Re: **Application for Planning Permit No. 1033/2018**  
Address: **472-474 St Kilda Road, MELBOURNE VIC 3004**

# PLANNING PERMIT

472-474 ST KILDA ROAD, MELBOURNE VIC 3004

Construct a multi-storey mixed use building, comprising a retail, food and drinks premises, bar, serviced apartments and dwellings, a reduction in the number of car parking spaces required and a licence for the sale and consumption of liquor.

Drawing Number:  
**TP-20-99**

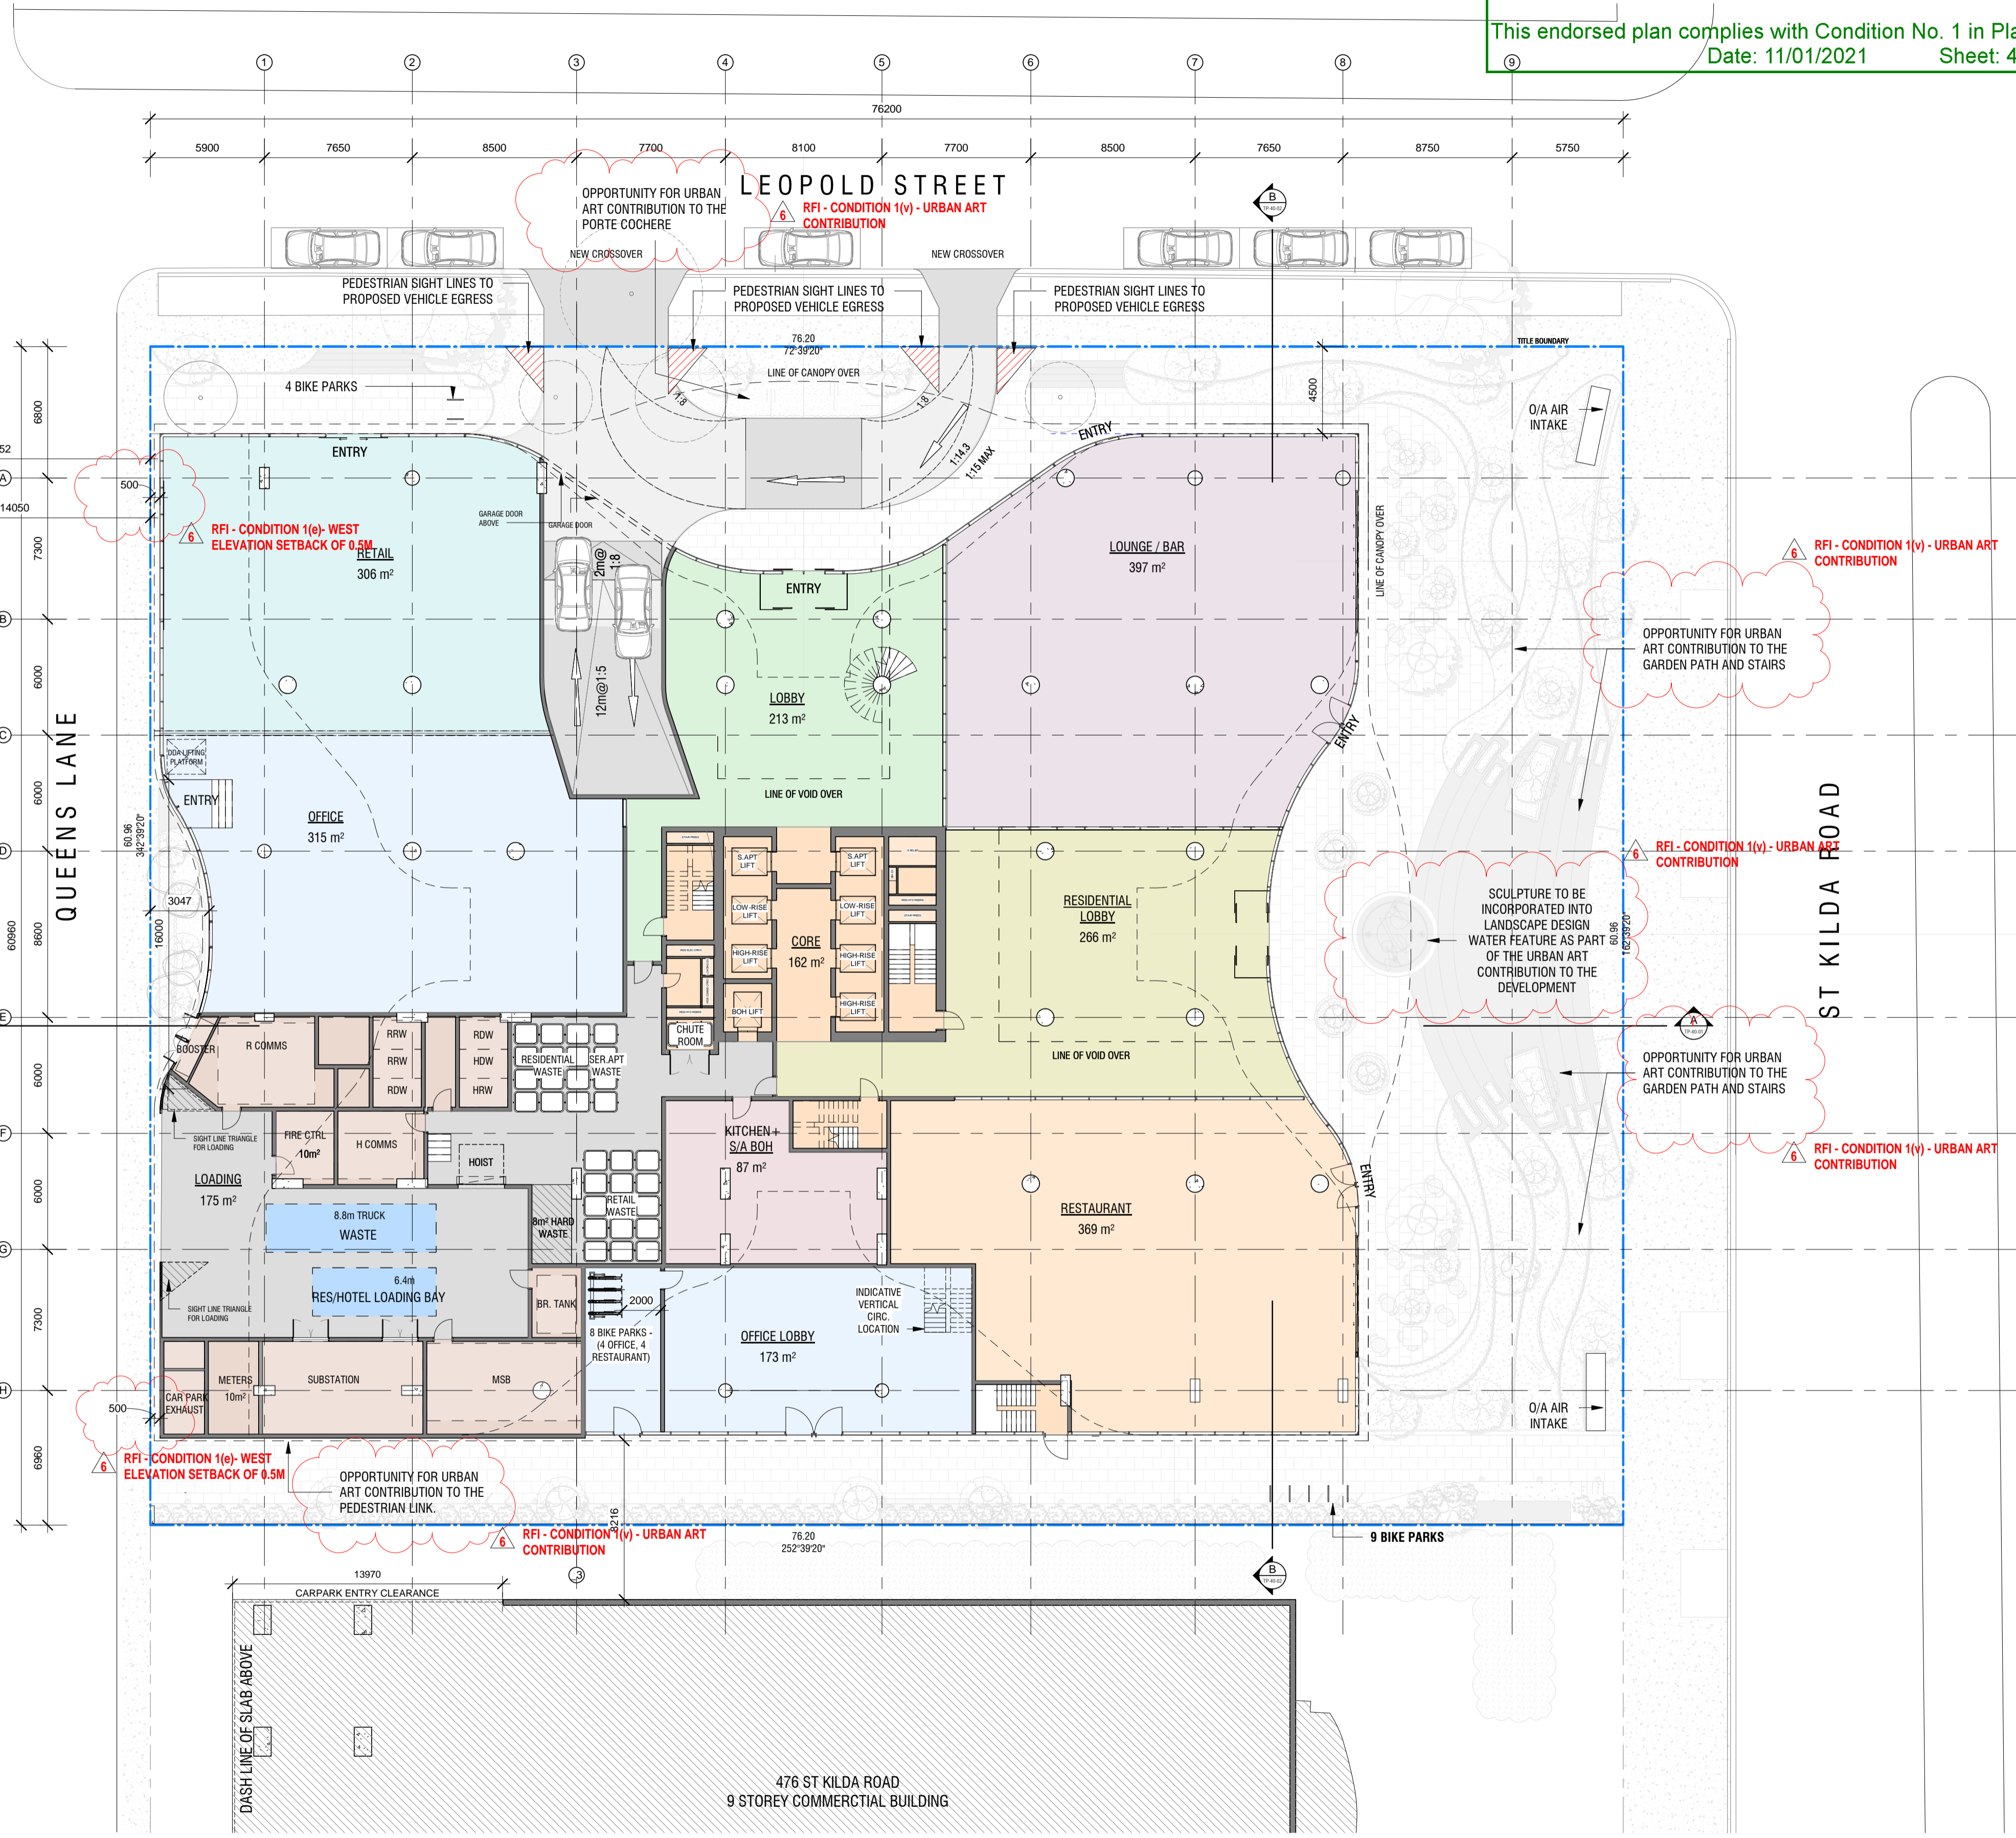
RFI - CONDITION 1(g)- SIGNAGE DIRECTING BICYCLE PARKING

Drawing Number:  
**TP-21-10**

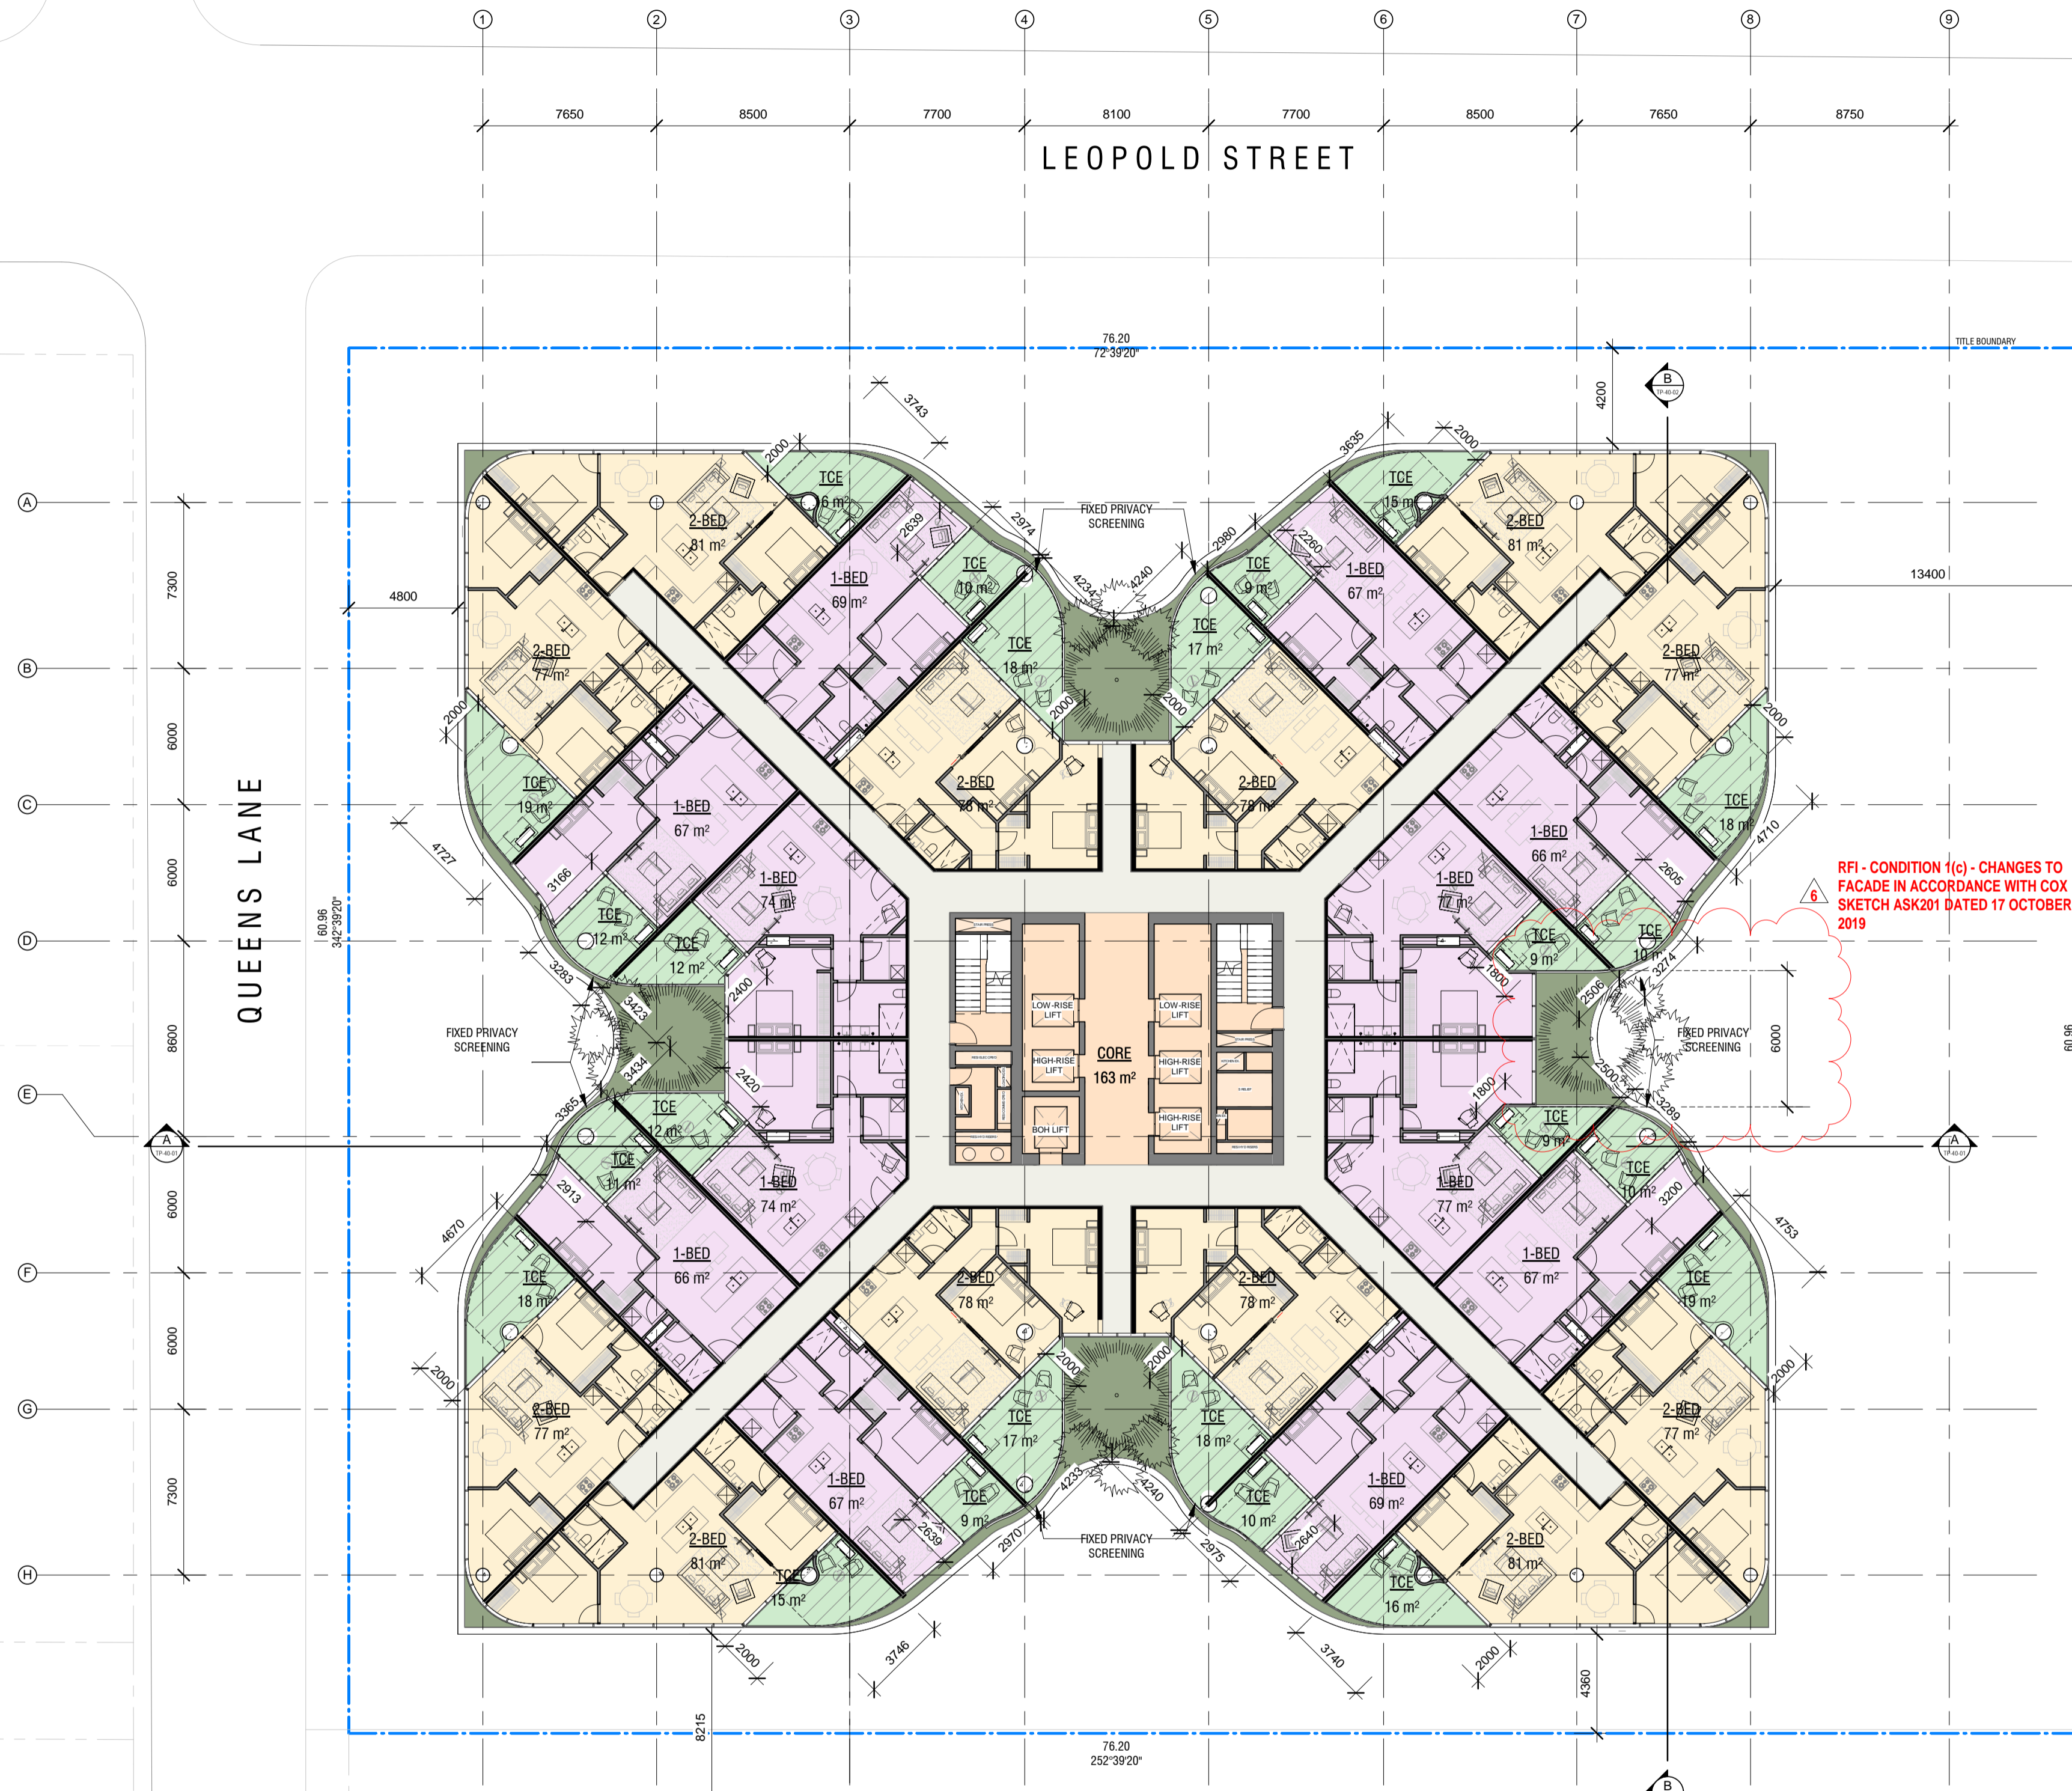
RFI - CONDITION 1(c) - CHANGES TO FACADE IN ACCORDANCE WITH COX SKETCH ASK201 DATED 17 OCTOBER 2019

Drawing Number:  
**TP-21-11**

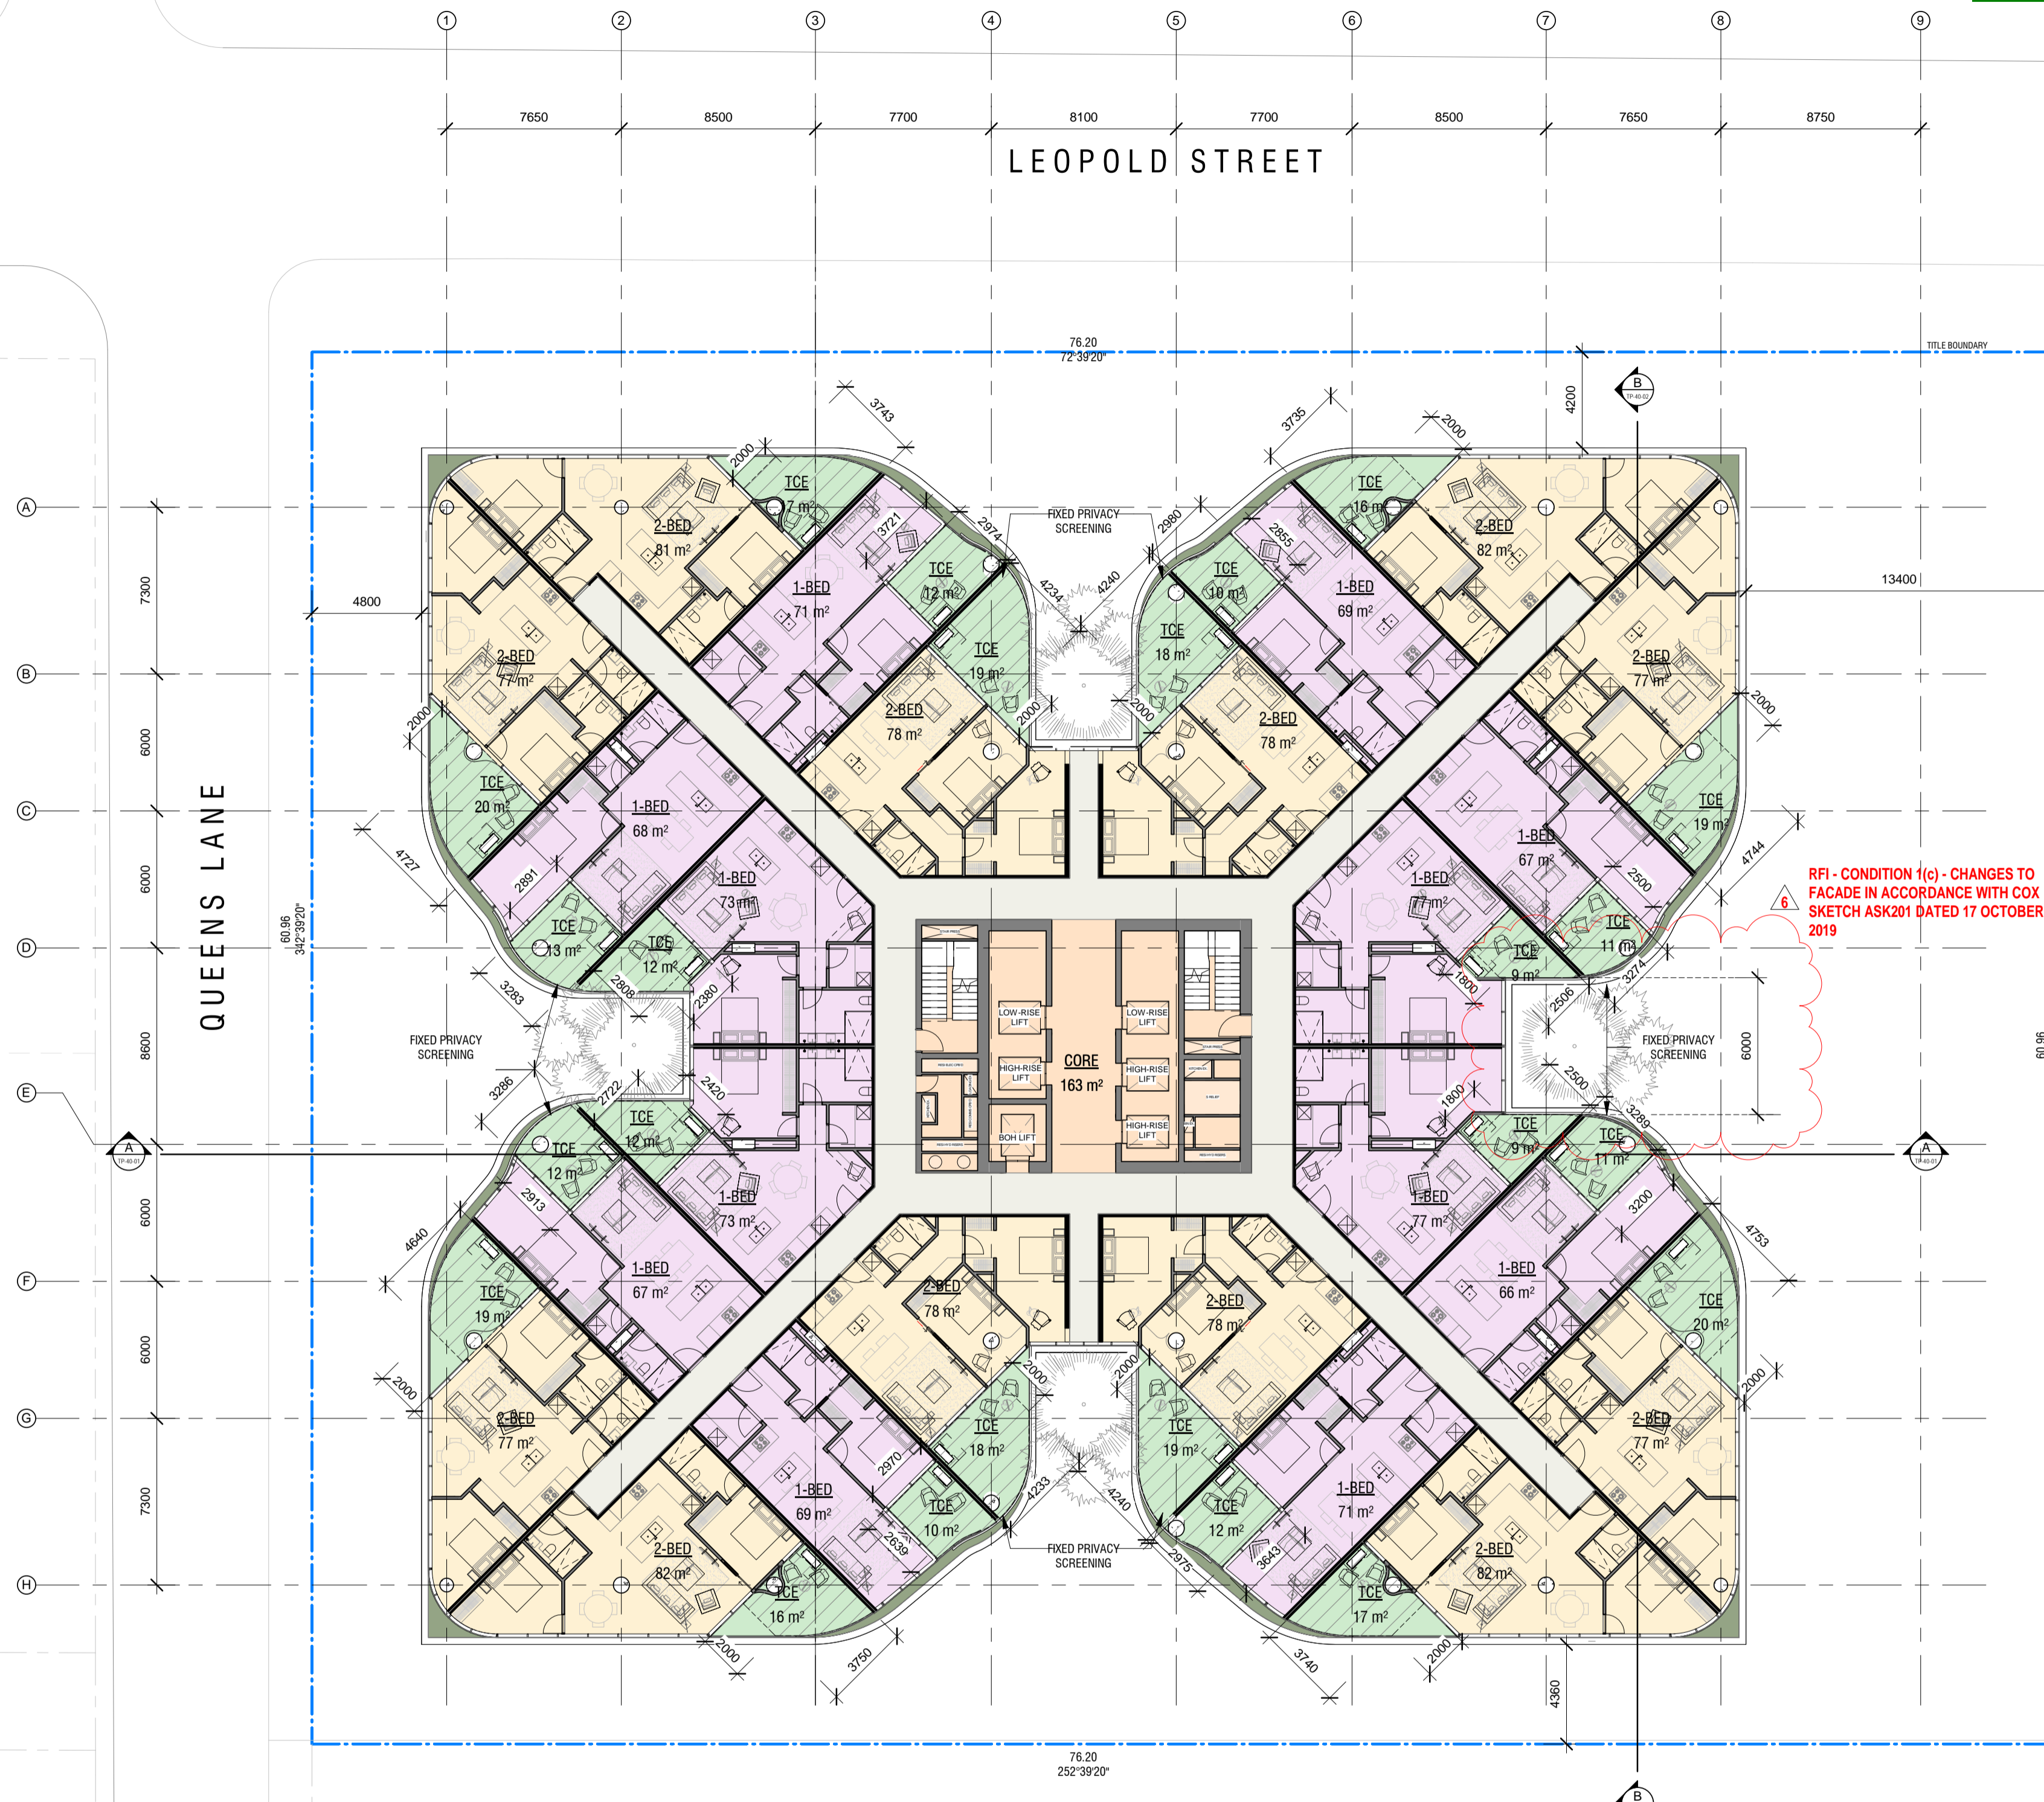
RFI - CONDITION 1(c) - CHANGES TO FACADE IN ACCORDANCE WITH COX SKETCH ASK201 DATED 17 OCTOBER 2019
